MAB Submission to Amendment C296 to the Casey Planning - Croskell Precinct Structure Plan

// Submission to Amendment C296 – Croskell (Employment) Precinct Structure Plan MAB Submission

Figure 2 – Draft PSP Place Based Plan

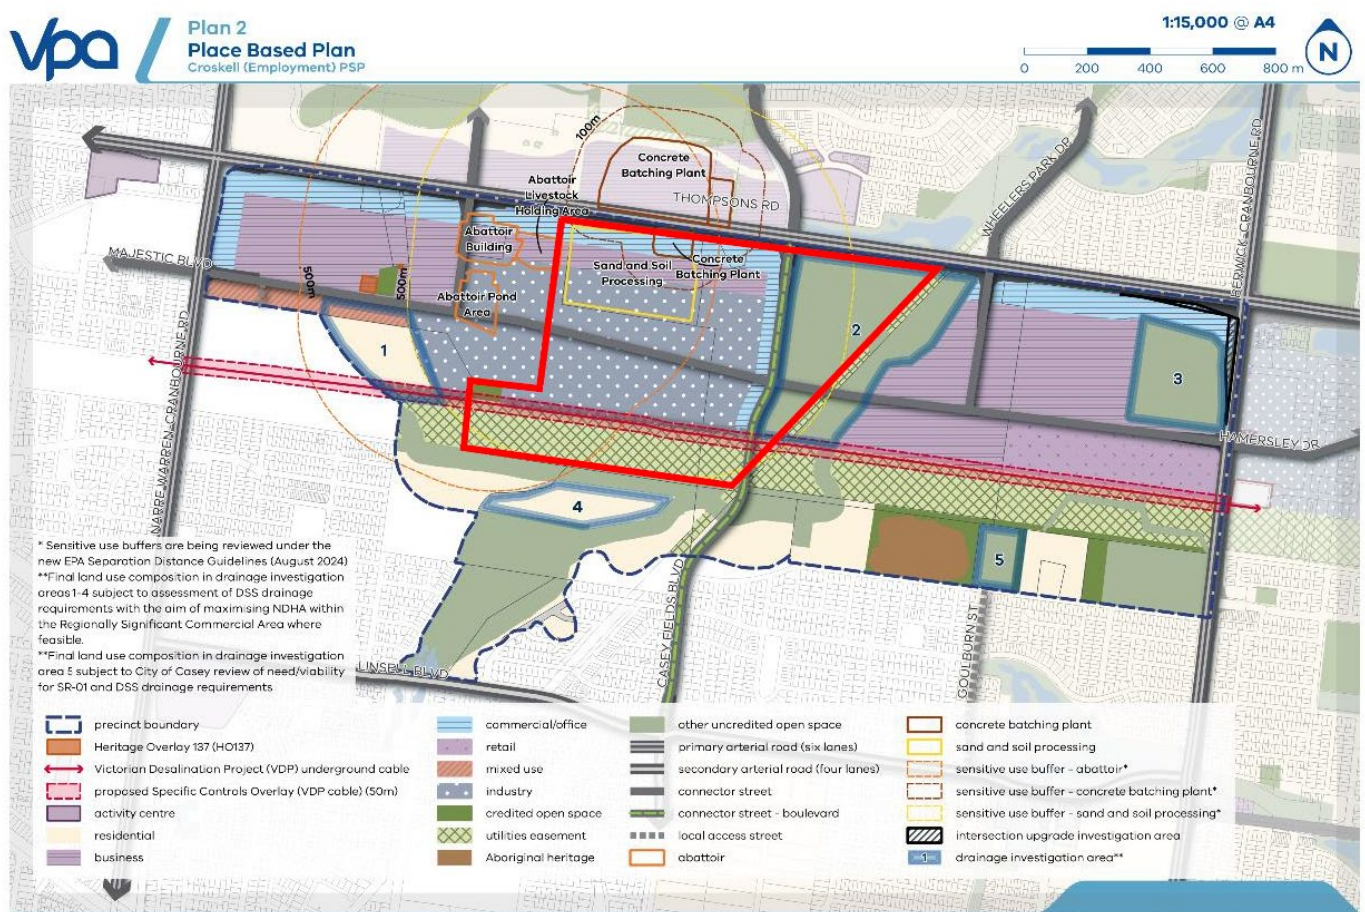
Drainage Investigation Area 2 is shown on the MAB Property in the Draft Place Based Plan in **Figure 2** below. MAB has significant concerns with Drainage Investigation Area 2 as it is currently shown as it encumbers an additional 9 hectares (approximately) of strategic land fronting Thompsons Road and Casey Fields Boulevard that has the potential to support high-quality industrial uses. Importantly, this additional area identified for drainage is located outside of the existing Urban Floodway Zone (UFZ) and the Land Subject to Inundation Overlay (LSIO) as shown in **Figure 4**.

Figure 3 – Draft PSP Infrastructure and Development Staging

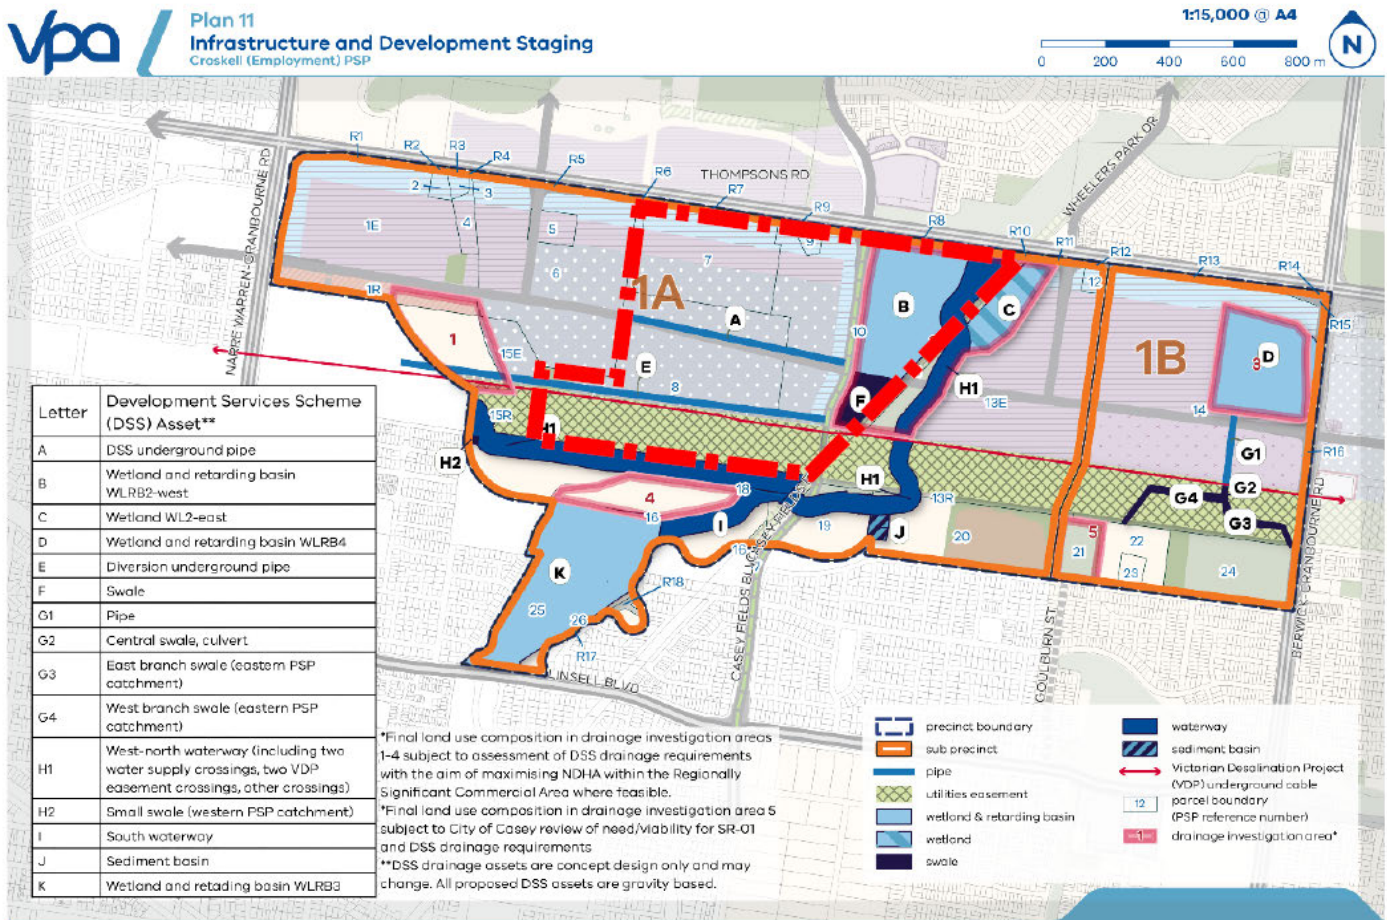
Section 3 and Plan 11 (Infrastructure and Development Staging) of the Draft PSP shown in **Figure 3** identifies the following proposed Development Services Scheme (**PSP DSS**) assets on the MAB Property:

- A: DSS underground pipes;
- B: Wetland and retarding basin WLRB2 - West;
- F: Swale; and
- E: Diversion underground pipe.

Drainage Investigation Area 2 as currently shown in the draft PSP severely impacts the opportunity to deliver a functional development suitable for industry on the MAB Property. Following recent discussions during the consultation period with the VPA and MWC, MAB is of the view that the proposed PSP DSS:

- Underutilises the existing UFZ/LSIO land on the Property which is inconsistent with one of Melbourne Water's own objectives to utilise encumbered land for drainage purposes – reducing the availability of much needed land for industrial development;

- Severely compromises urban design outcomes associated with the Thompsons Road and Casey Fields Boulevard interfaces, which would be dominated by drainage infrastructure, limiting active employment uses;

- Creates an unnecessarily expensive DSS which would significantly impact the timely activation of the PSP;
- The cost of the proposed DSS would be unnecessarily higher;

- Impacts the proposed east-west connector street required to connect Berwick-Cranbourne and Narre Warren-Cranbourne Roads by splitting the proposed WLRB2 – West (B) and the Swale (F), compromising the function of these drainage assets;

- Leads to a reduction in the PSP's overall employment land and increases the Infrastructure Contribution Plan (ICP) supplementary levy; and
- Creates a development timing constraint for Stage 1A (western portion of the PSP) as shown in **Figure 3** due to reliance on drainage infrastructure in the MAB Property to service neighbouring sites.

Figure 4 – Extent of UGZ/LSIO on MAB Property

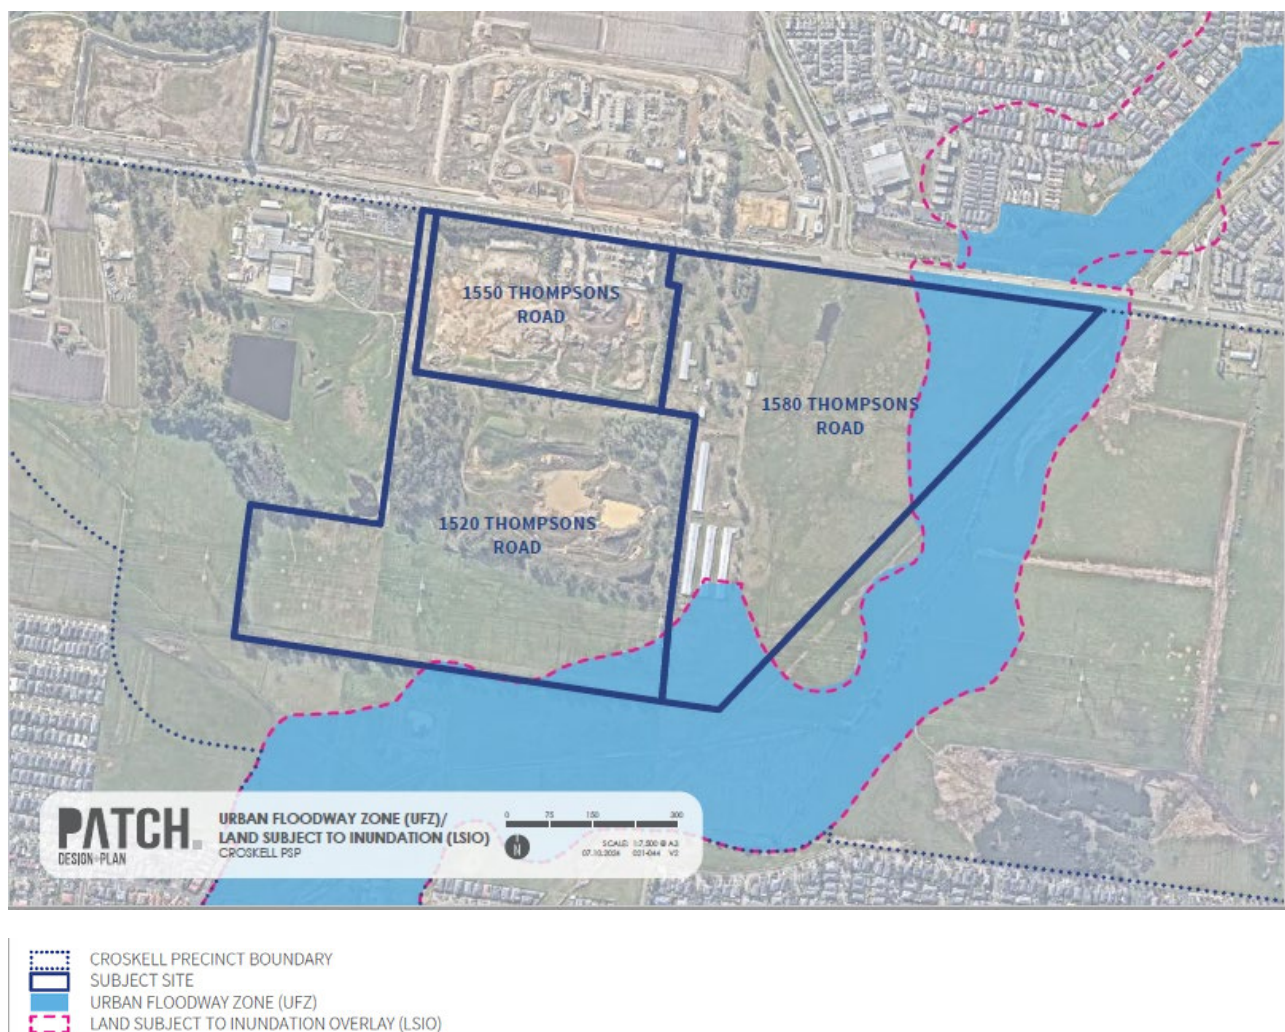
Figure 4 below shows the extent of UGZ/LSIO land within the MAB Property in light blue.

Preliminary technical background work prepared by MWC and their hydraulic consultant Water for Good (**W4G**) in October 2022 supported an option for a DSS layout that confined drainage assets within the UGZ/LSIO extent – minimising impacts on unencumbered land.

MAB's DSS investigation confirms that the size of WLRB2 - West can be accommodated within the footprint of the existing UGZ/LSIO as:

- There is a high-flow bypass contained within the reserve which is redundant given the waterway is immediately adjacent to the wetland;
- The proposed sediment drying areas are located on high value land in the PSP and could be relocated to a landlocked area on the east side of the waterway;
- An engineered solution would enable dry weather access to this sediment drying area utilising the proposed shared use path along the south side of Thompsons Road; and
- If the channel shaped area is not needed for water quality, it should be removed.

Figure 5 – MAB proposed revised WLRB2 – West Design

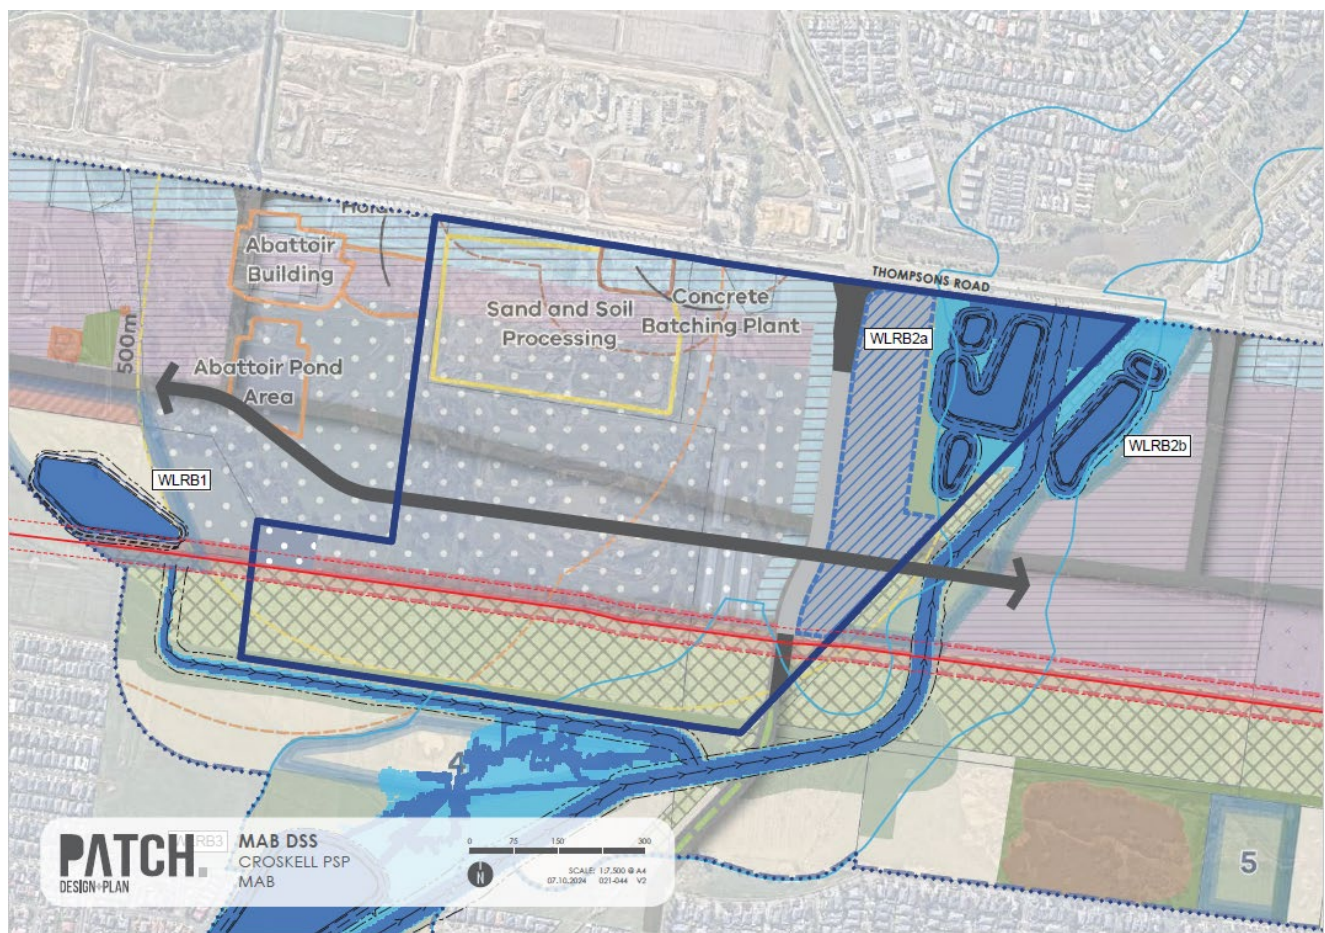
Figure 5 below provides a conceptual interpretation of MAB's DSS design of WLRB2 - west which shows a revised layout overlaid on Plan 2 of the PSP.

This was presented to MWC on 30 September 2024 and MAB received confirmation on 4 October of MWC's support for the layout in MAB's DSS, subject to meeting current MWC design standards and managing site constraints. Further discussions are required prior to the SAC hearing to refine the MAB DSS proposed design; however, the layout demonstrates how WLRB2 - West can be designed to be contained wholly within the UFZ on MAB's Property resulting in a materially less expensive overall DSS and meeting the demand for employment land in a key location.

Figure 7 – Extended Industry designation – MAB Property

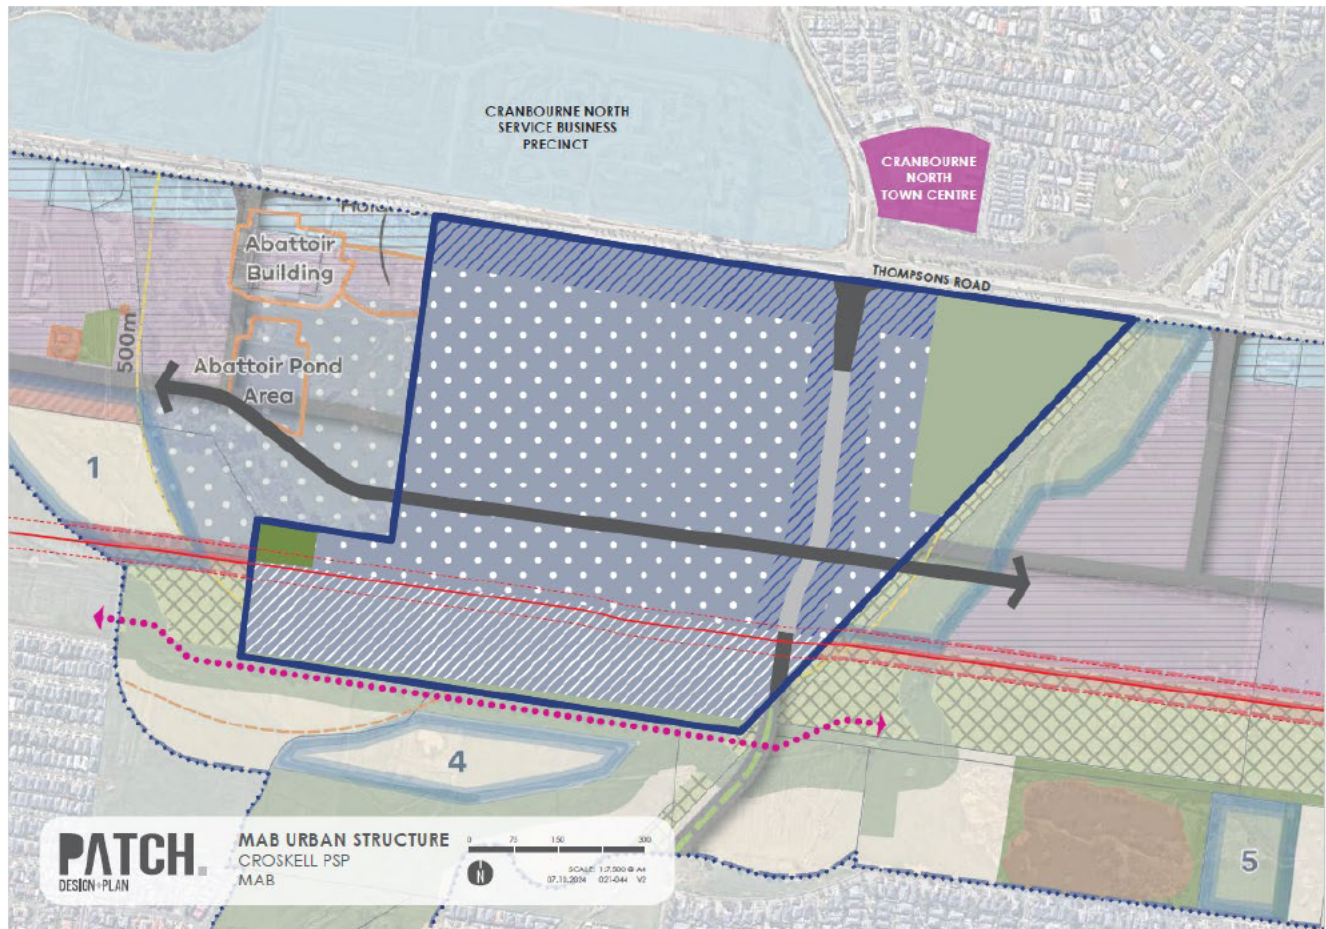
MAB requests that Plan 2 in the current PSP be amended to designate whole of the MAB Property as “Industry” and that the Commercial/Office and Business designation be removed as this approach to controlling employment land use outcomes has the potential to:

- Limit and delay the activation of key frontages along Thompsons Road and Casey Fields Boulevard in the immediate term negating the opportunity for an industrial use that may deliver a high-quality built form and urban design outcome;
- Set arbitrary development and allotment depths that would render these areas potentially inactive for an extended period given the expected low demand for commercial and offices uses in Casey outside of Activity Centres; and
- Discourage major corporate occupiers that require varying lot depths by providing uncertainty at the Planning Permit stage based on the need to locate within the commercial/office area.

Figure 7 below shows the extent of Industry proposed, with specific reference to design controls that could be applied to key interfaces.

Figure 8 – Industry under High Voltage Transmission Easement

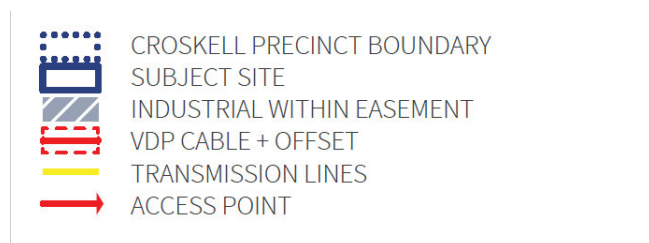
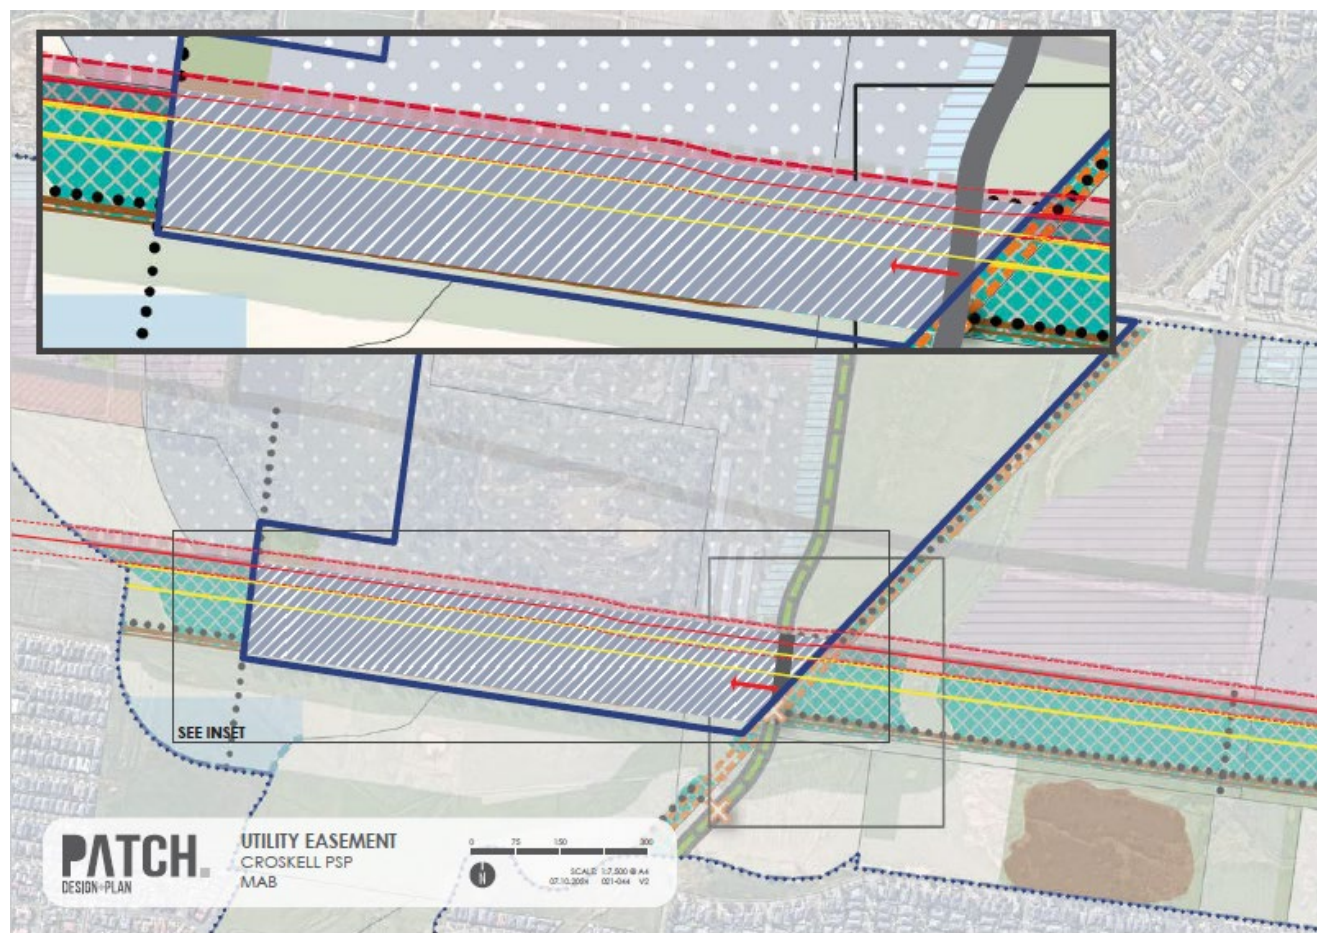
4.2 Extend Industry under the High Voltage Transmission Easement

MAB requests that PSP Plan 2 (and all other relevant plans) be amended to show Industry, south of the easement on MAB’s Property outside of the VDP cable area.

Figure 9 – Industrial Diversion Underground Pipe (20m)

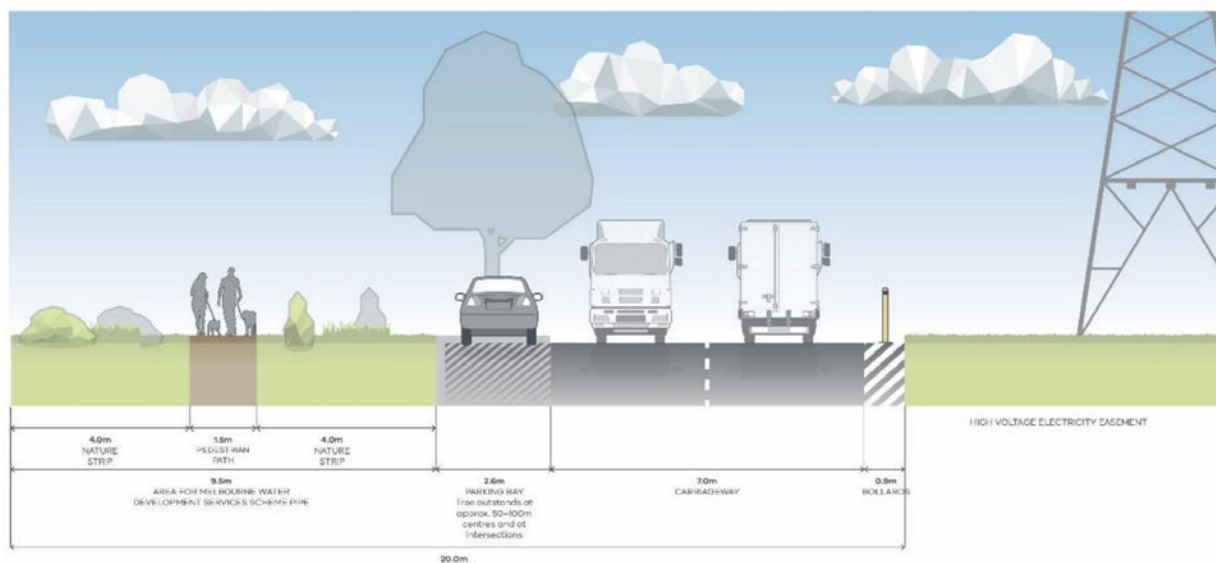
As outlined in Submission A, the diversion pipe should cater for Q100 flows. Therefore the “Local Access Street Level 2 – Industrial / Diversion Underground Pipe (20 m)” section is redundant and should be removed from the PSP. R8 should also be deleted. **Figure 9** below is the relevant diagram from the PSP which MAB submits should be deleted.

The PSP should enable the final form and specific location of the diversion pipe to be dealt with at subdivision permit stage to relevant agency requirements at the planning permit stage and a note should be added to relevant PSP plans to reference to indicate this.
